Model No. **SA-XH10EE**

Subject : Block Diagram, Schematic Diagram, Printed Circuit Board & Replacement Parts List (Updates).

Please file and use this supplement manual together with the service manual for

SA-XH10EE
MAIN P.C.B.

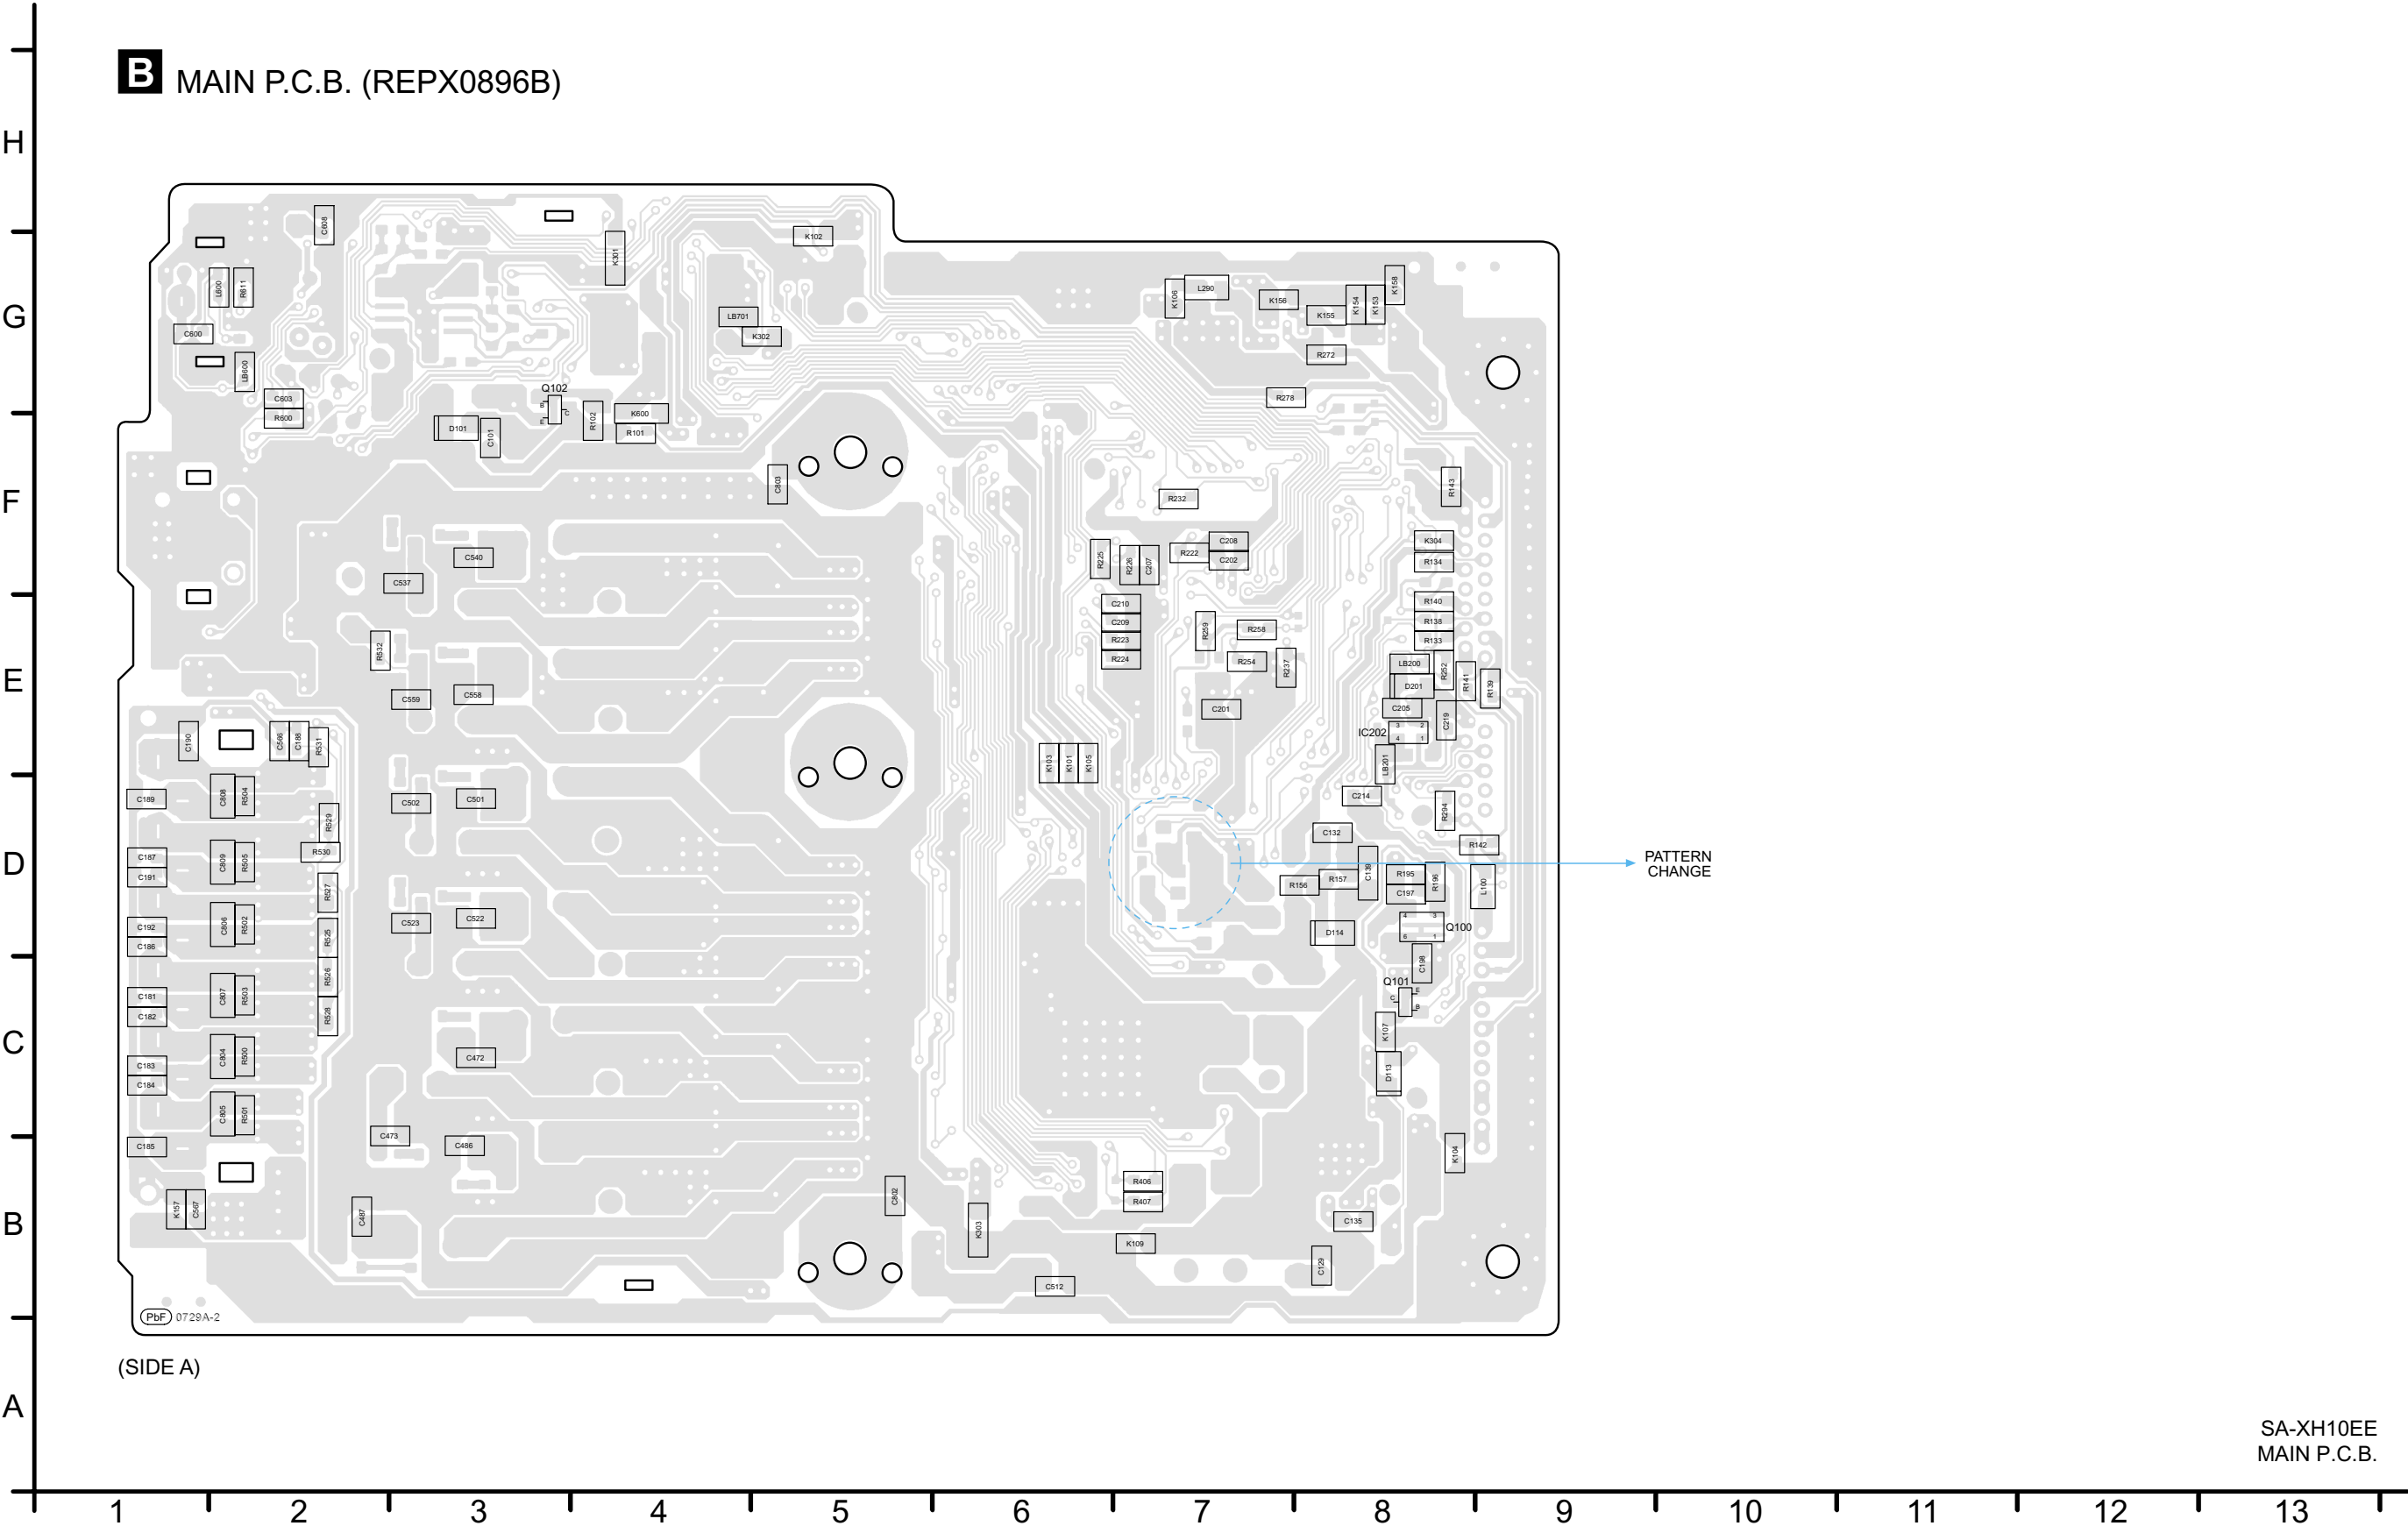
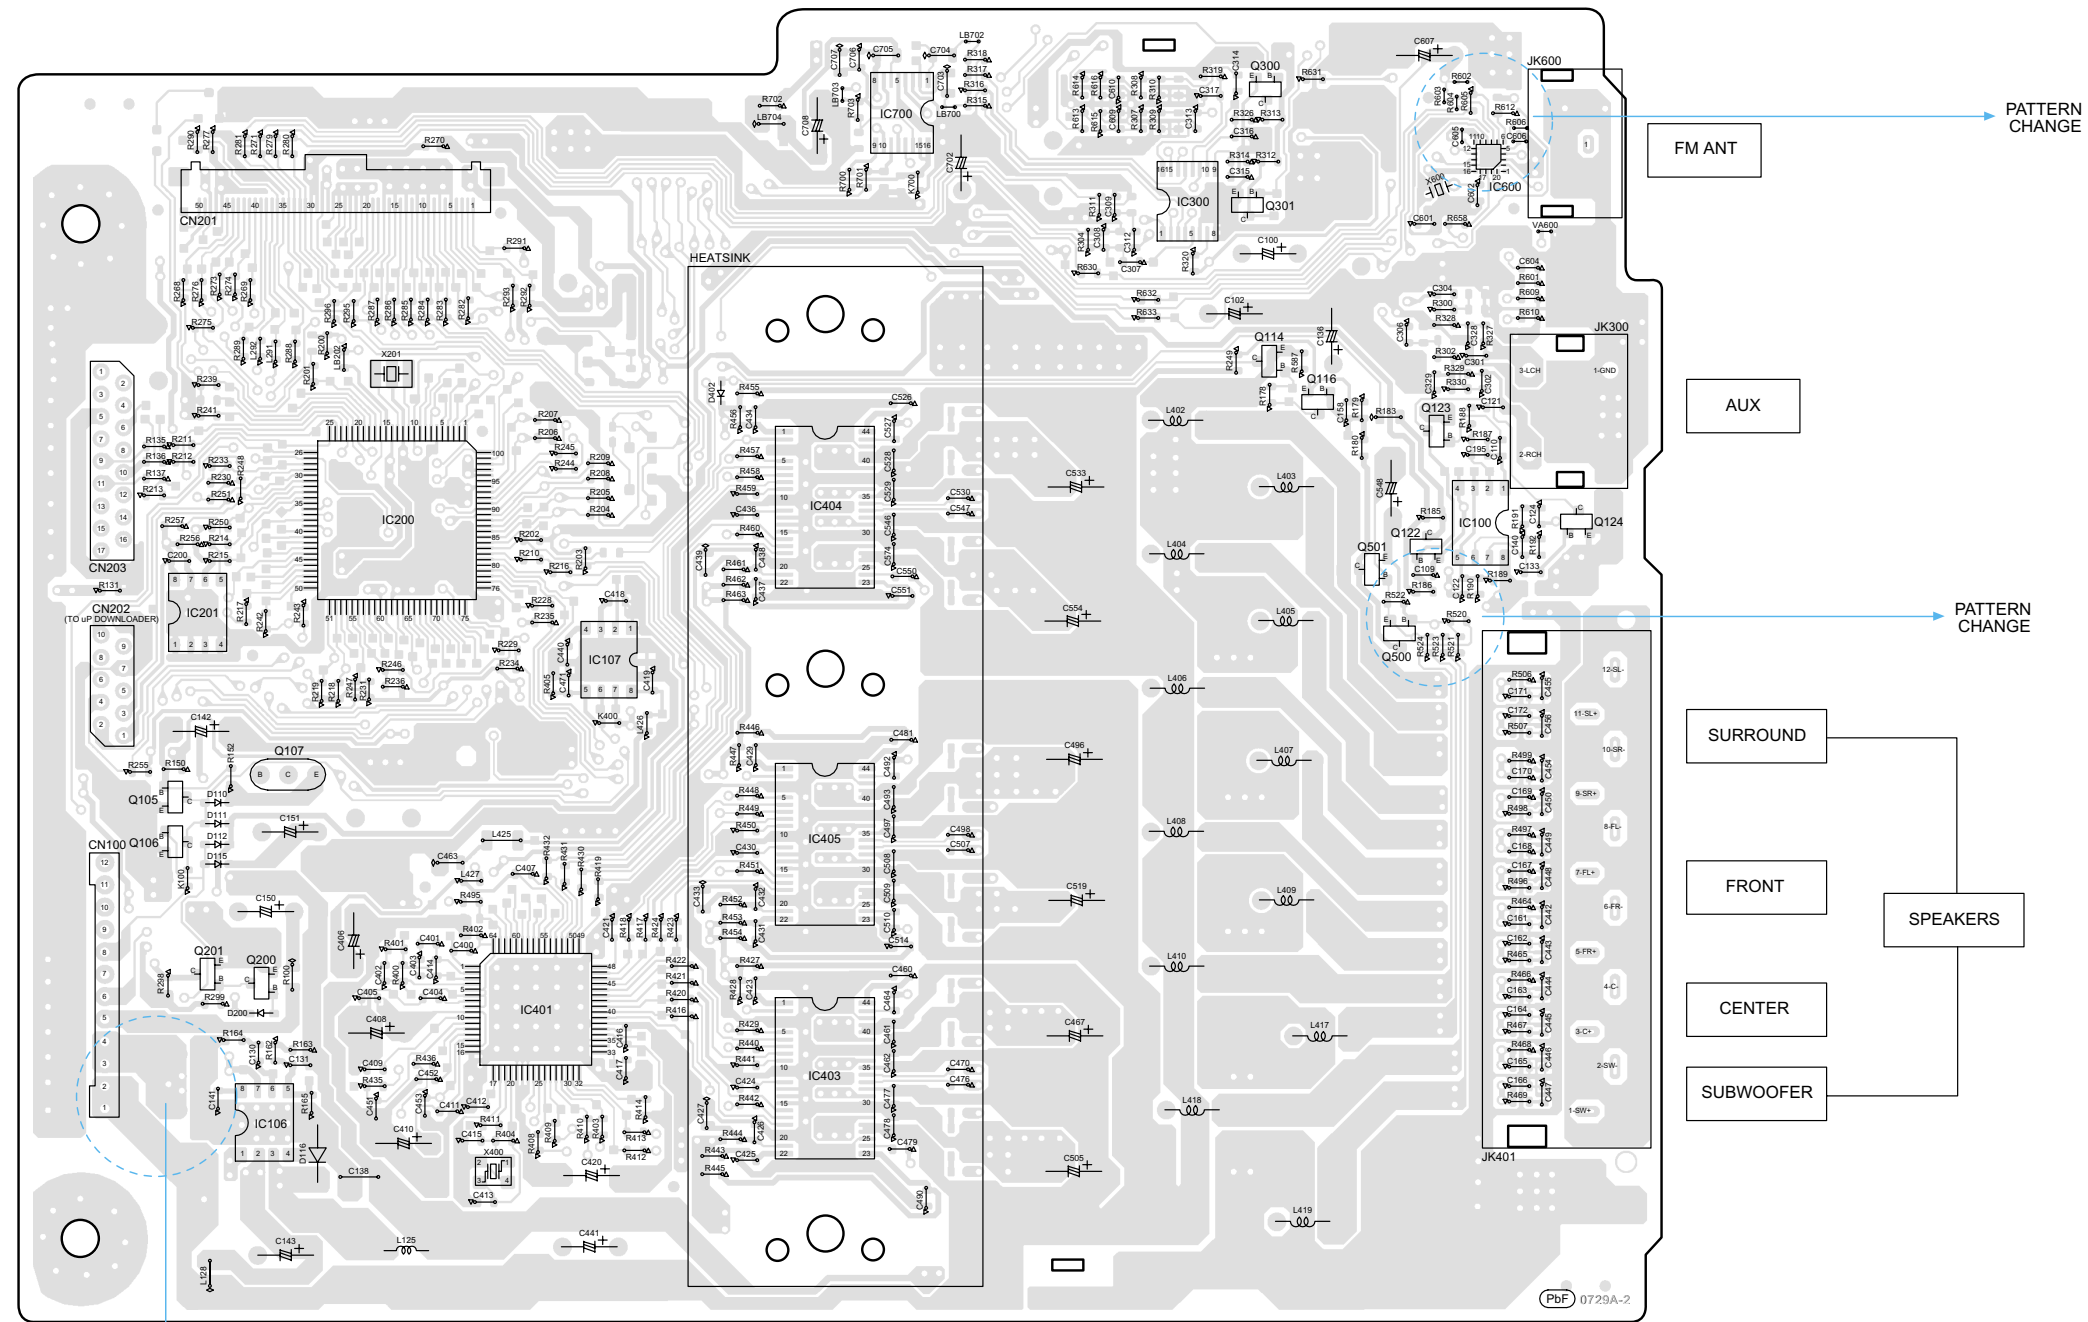
(SIDE B)
PATTERN
CHANGE
DELETE
(L421, L422)
